BL417 Geological Sciences Phase 2 F100 IGWS East
(F100) Lab Renovations
IU 20250361

ADDENDUM NO. 3
14217

Addendum #3

RE: Indiana University
BL417 GEOLOGICAL
SCIENCES - FACULTY
100 - GEOLOGICAL
SCIENCES

SECOND FLOOR PLUMBING PLANS P202

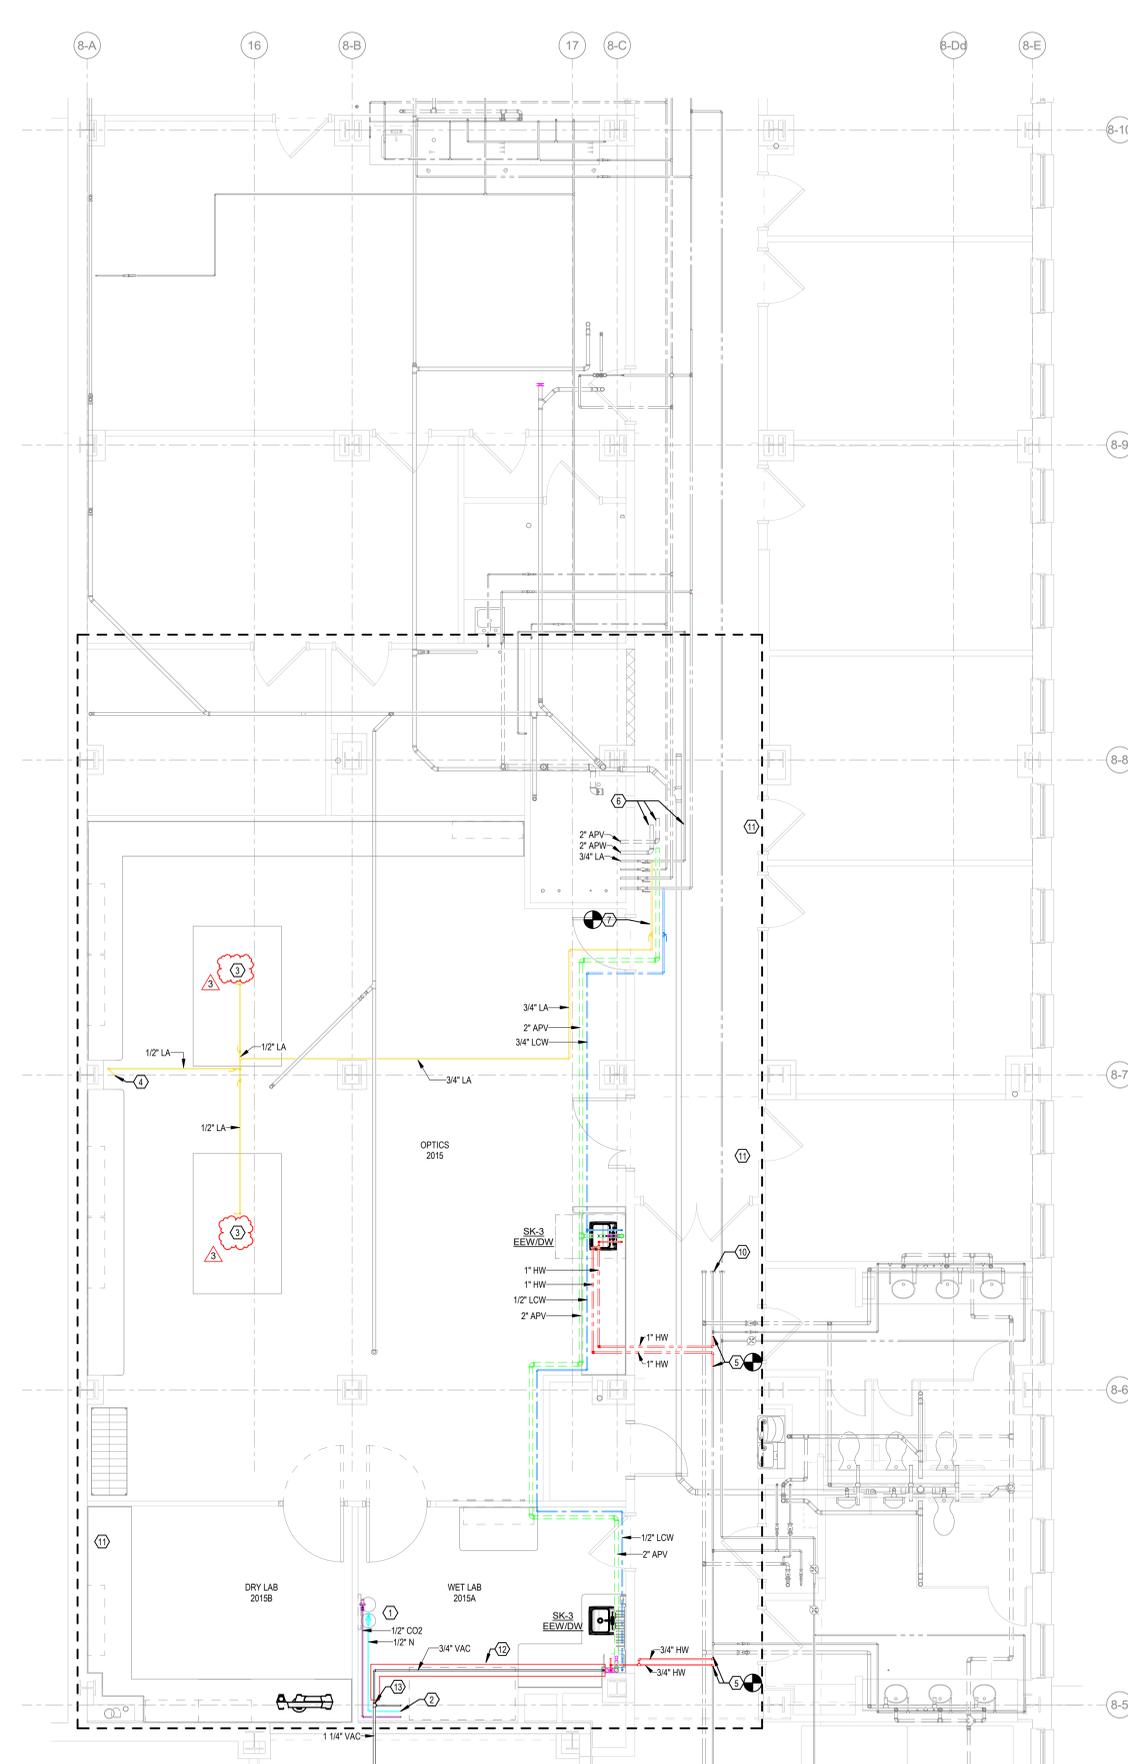
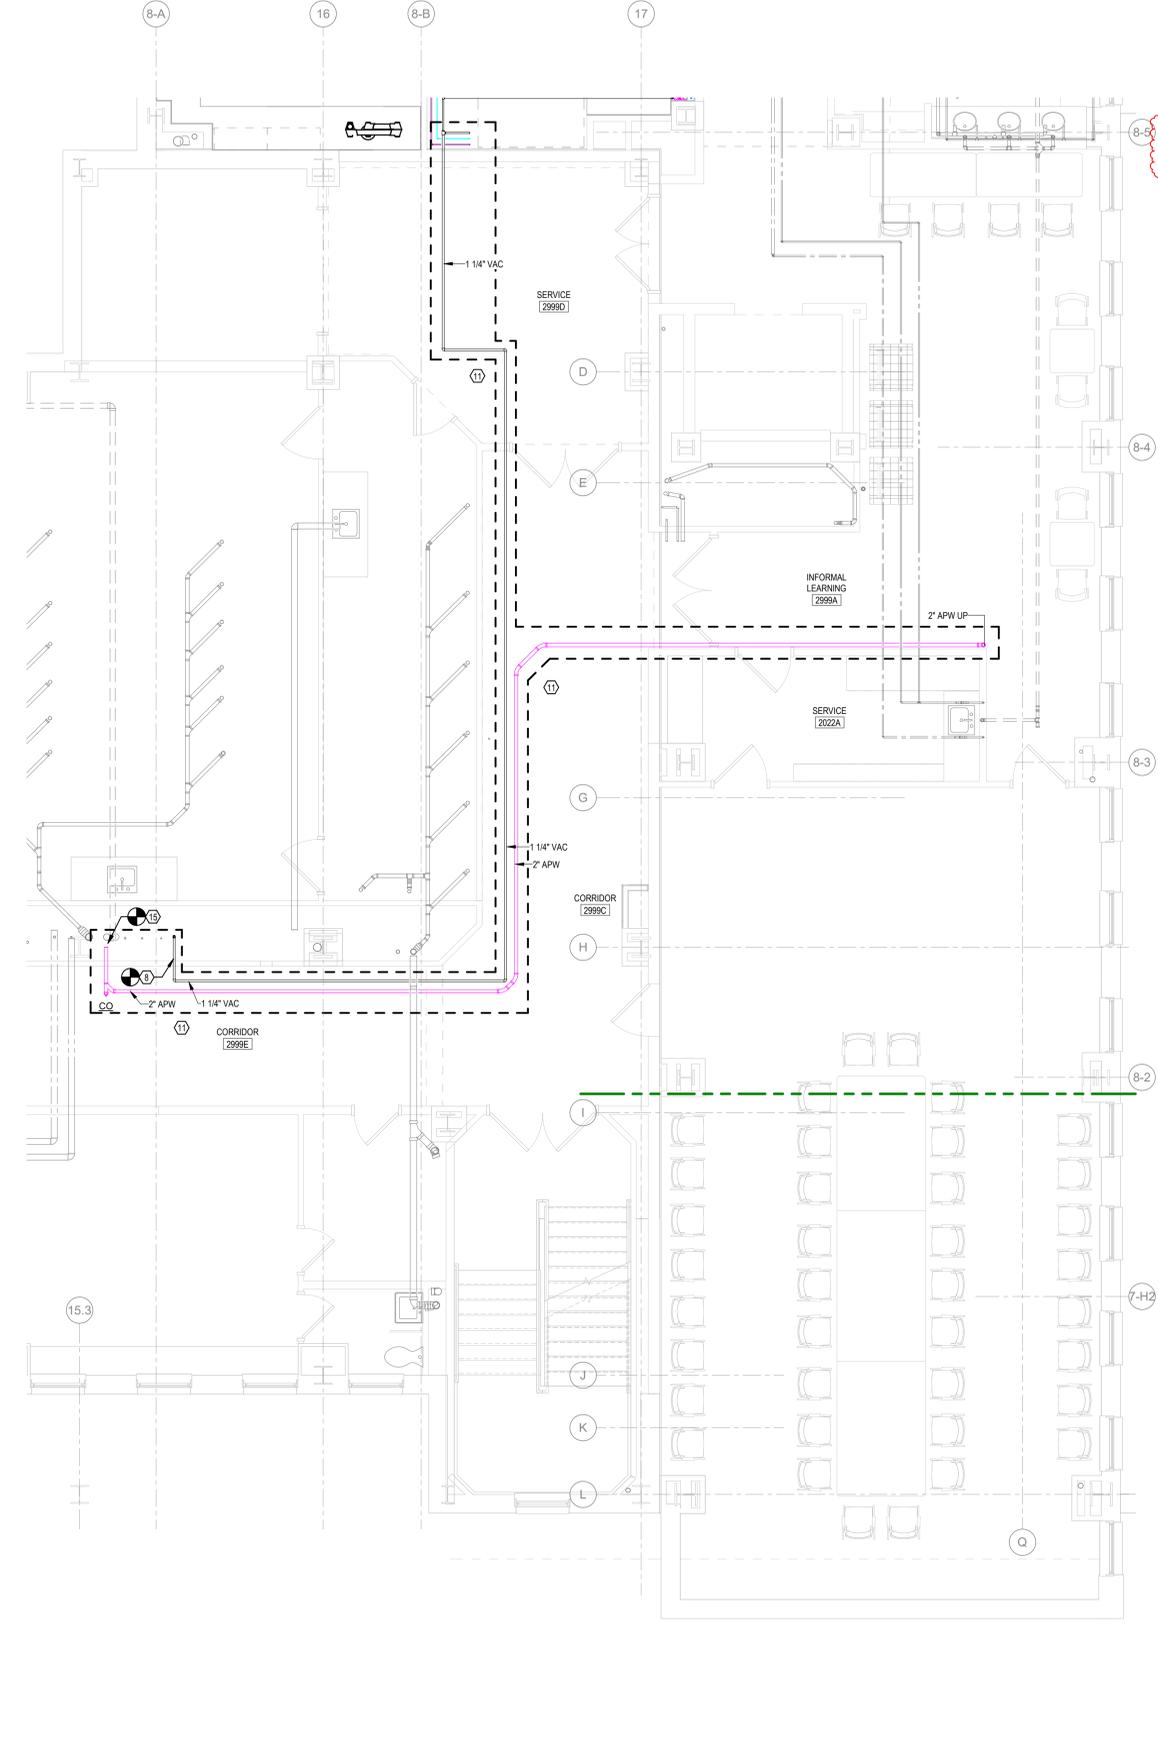
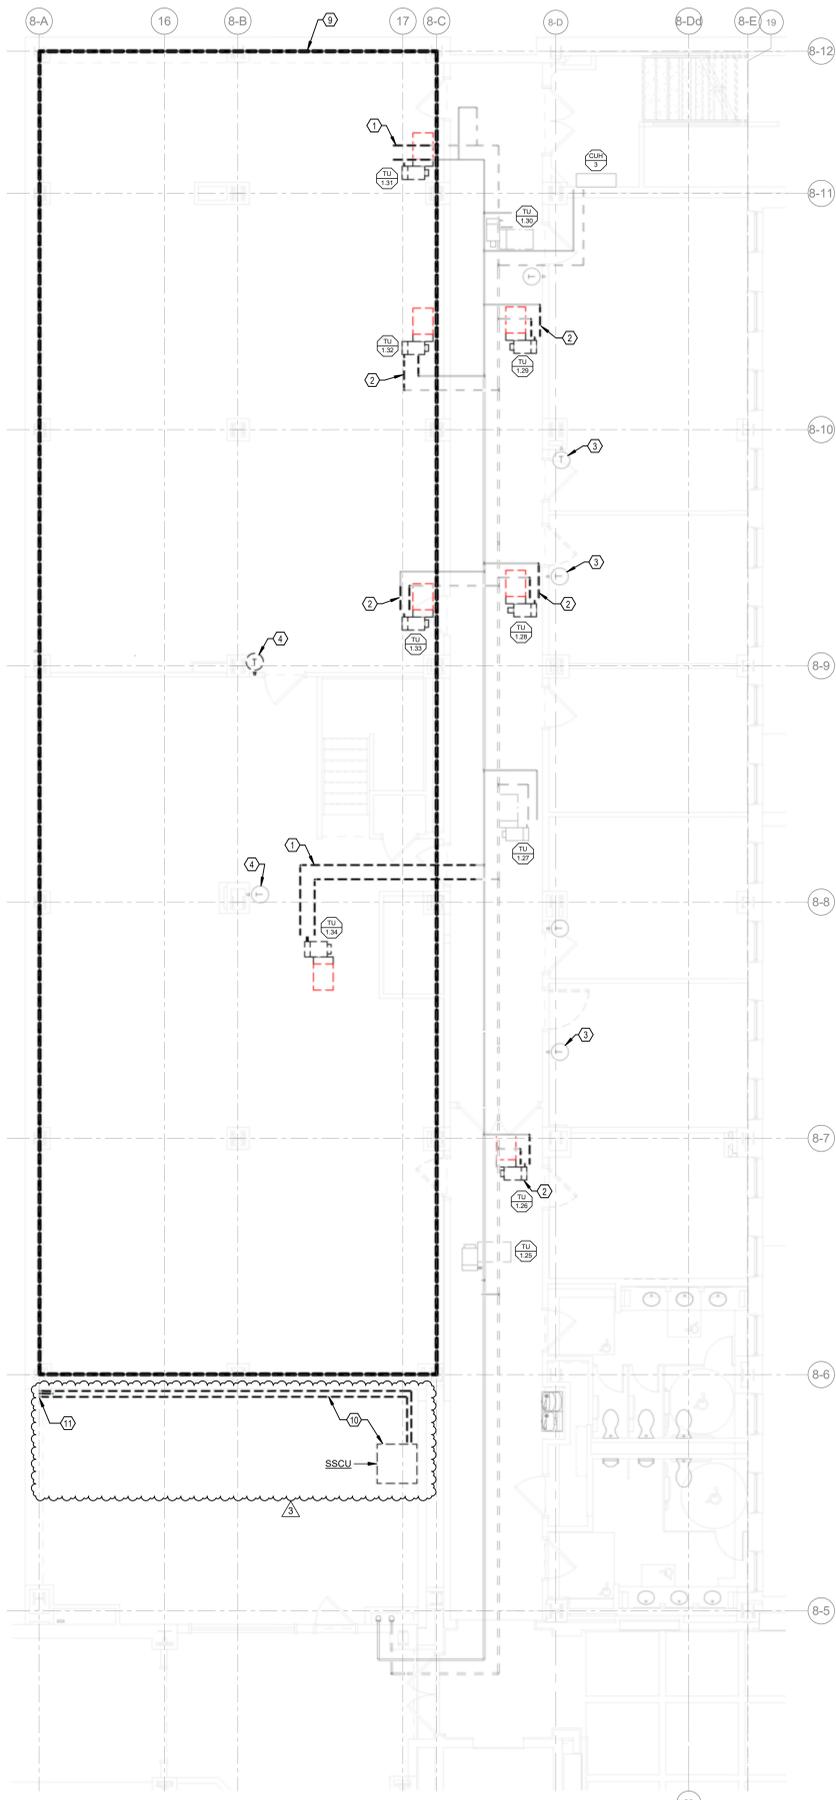
1. Sheet P202 – SECOND FLOOR PLUMBING PLANS
 - a. Modified plan note.
2. Sheet H101 – FIRST FLOOR HVAC DEMOLITION PLANS
 - a. Added ductless split system condensing unit and refrigerant piping to be removed.

FIRST FLOOR
NORTH HVAC
DEMOLITION
PLANS
H101

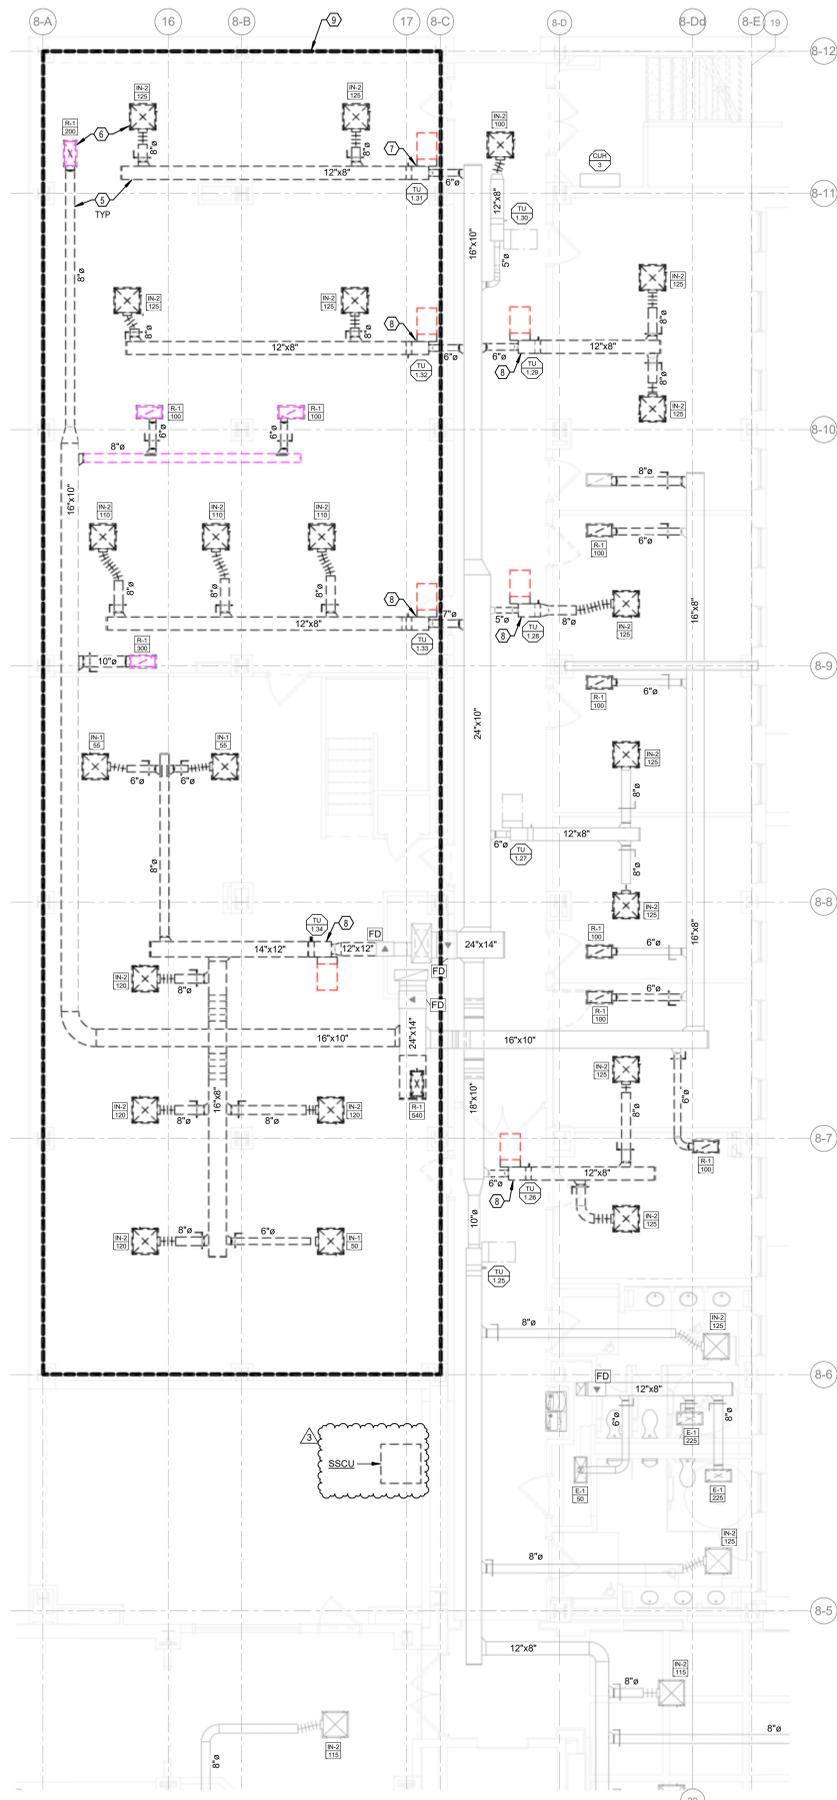
- b. Clarified notes on VAV box piping and valve removal. In general, if a VAV box is to be relocated, the hot water temperature control valve needs to be relocated with that box. The other shutoff valves, strainer, flow control valve, etc can remain if there is a replacement box being installed in that same location, or contractor can relocate the entire valve package with the VAV box (contractor discretion). If there is a new VAV box in a new location, then contractor is to provide a new set of valves and install the new control valve from Siemens. This is typical for all floors. See the VAV box schedule for additional information on which boxes are new and which ones are relocated. Contractor may also re-use existing valve packages that were removed from a VAV box that is shown to be removed with no replacement shown near its existing location, as long as they are sized appropriately.

- 9 ALL WORK WITH ROOMS 1006 AND 1011 SHALL BE BID AS PART OF ALTERNATE #1.
- 10 REMOVE EXISTING DUCTLESS SPLIT SYSTEM CONDENSING UNIT AND ASSOCIATED REFRIGERANT PIPING COMPLETE.
